FOR PERCOLATION TESTING AND SITE EVALUATION

RE: PERCOLATION TEST RESULTS, 13744 Lakeside Drive, A530221

- ANY CHANGES TO A PRIVATE SEWERAGE EASEMENT SHALL REQUIRE A REVISED PERCOLATION CERTIFICATION PLAN.
 - THE PURPOSE FOR THIS PERCOLATION CERTIFICATION PLAN IS TO ADJUST THE BOUNDARIES OF THE EXISTING SEPTIC EASEMENT AS A GEOTHERMAL LOOP HAS BEEN INSTALLED IN THE AREA INITIALLY DESIGNATED AND PLATTED AS THE SEPTIC EASEMENT.

PLAN VIEW
SCALE: 1" = 50'

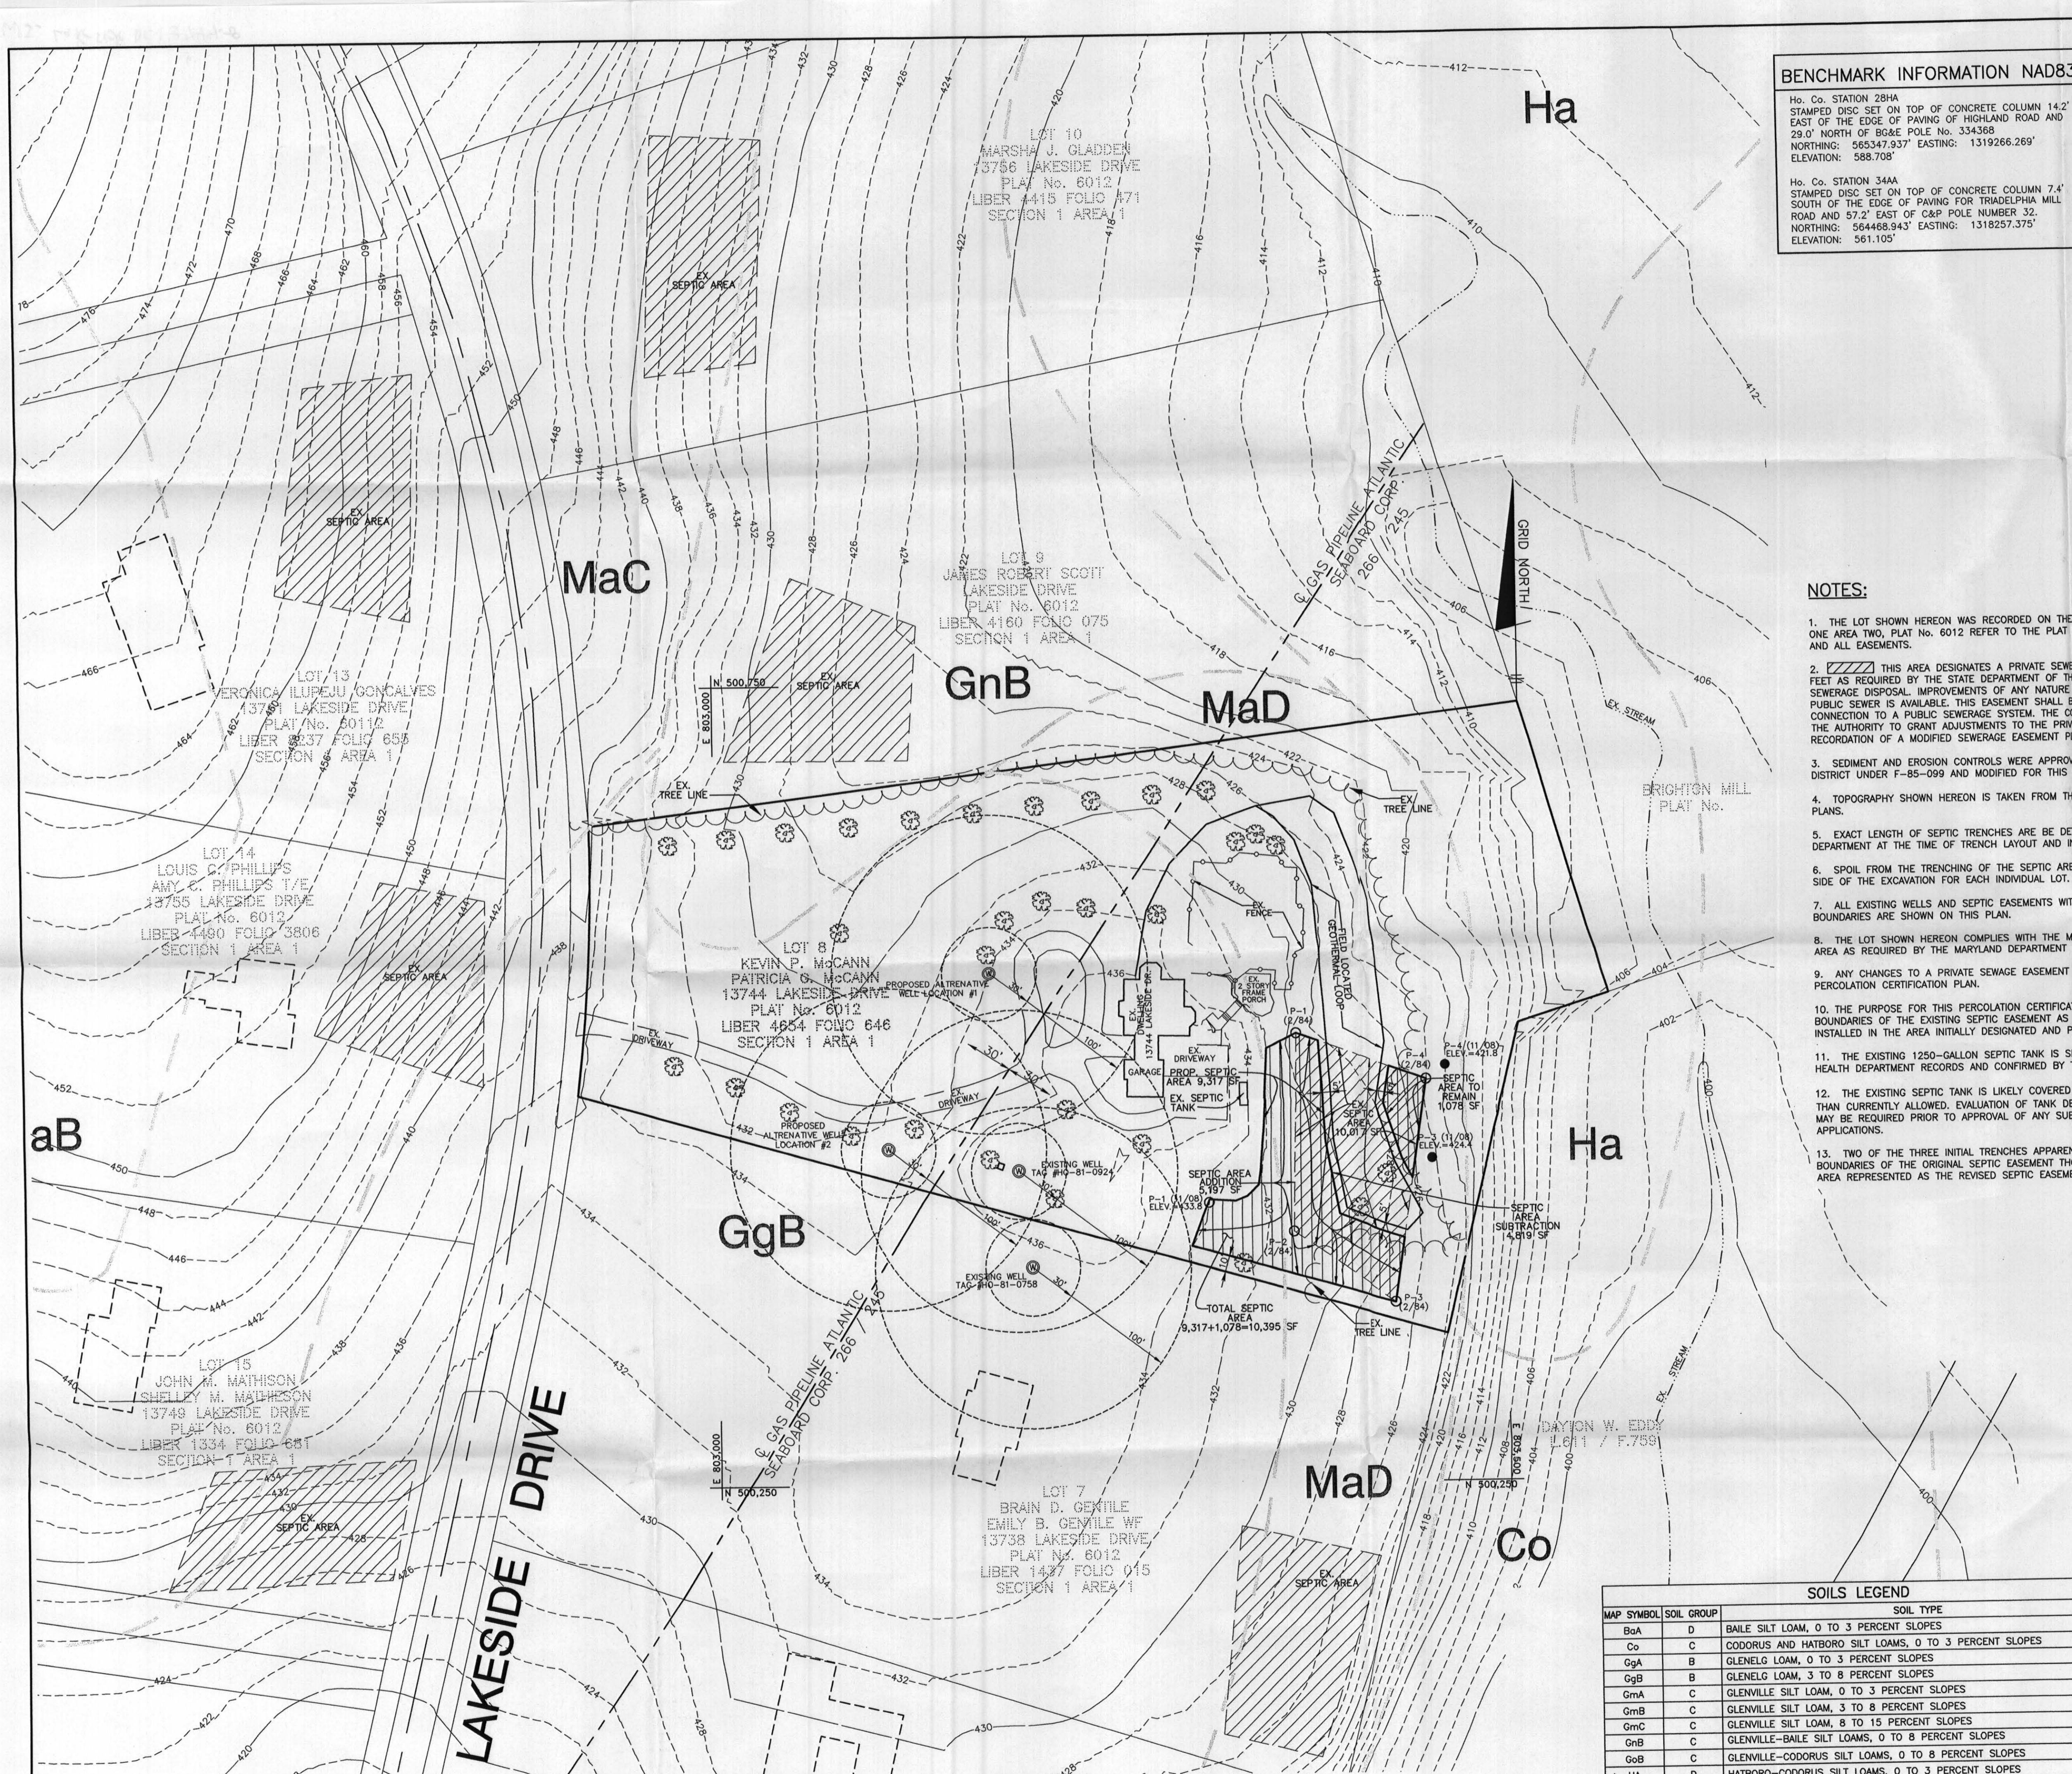
A test hole (P-1) was dug at the staked location representing an area to be added upslope of the existing septic easement. This soil profile is considered suitable for wastewater disposal. The subsoil ranges from a sandy loam with weak platy structure to a micaceous loamy sand saprolite. The moderately rapid percolation rate is similar to the rates of the tests conducted February 9, 1984. A repair system large enough to accommodate a 5-bedroom house can be installed from the P-1 location to the existing system.

It appears that the area proposed as septic easement along the south property line will accommodate a repair drainfield for the existing residence. The repair area is located downslope of the existing trenches and south of the geothermal loop. This area is represented by test location #3 (February 9, 1984).

Location P-2 was not dug as its location represents the same area as original percolation test #2 (February 9, 1984). There is topographic evidence that staked location P-2 is near two of the three existing drainfield trenches. (Please note that the existing trenches appear to be primarily in the area currently proposed to be added to the existing septic easement.).

A small area of the original septic easement is downslope and east of the horizontal geothermal loop. This area is very limited in size and an attempt was made to expand it. Locations P-3 and P-4 were attempted. Both of these locations failed due to the shallow depth to bedrock (approx. 2.5 feet). These two locations are slightly downslope

of the 1078 square feet identified as part of the existing septic easement that will remain. Therefore, the 1078 sq.ft.-area is not necessarily unproven and may remain in the septic easement as it was originally justified by test location #4 (February 9, 1984).

Test locations P-1, P-3 and P-4 must be surveyed. Also, the installed geothermal loop must be surveyed in the vicinity of the existing and proposed septic easement. These locations must be accurately presented on the Percolation Certification Plan currently being prepared. I believe the geothermal loop may be located by the metallicized tape that overlies the conduits lining each wall of the geothermal system's trench.
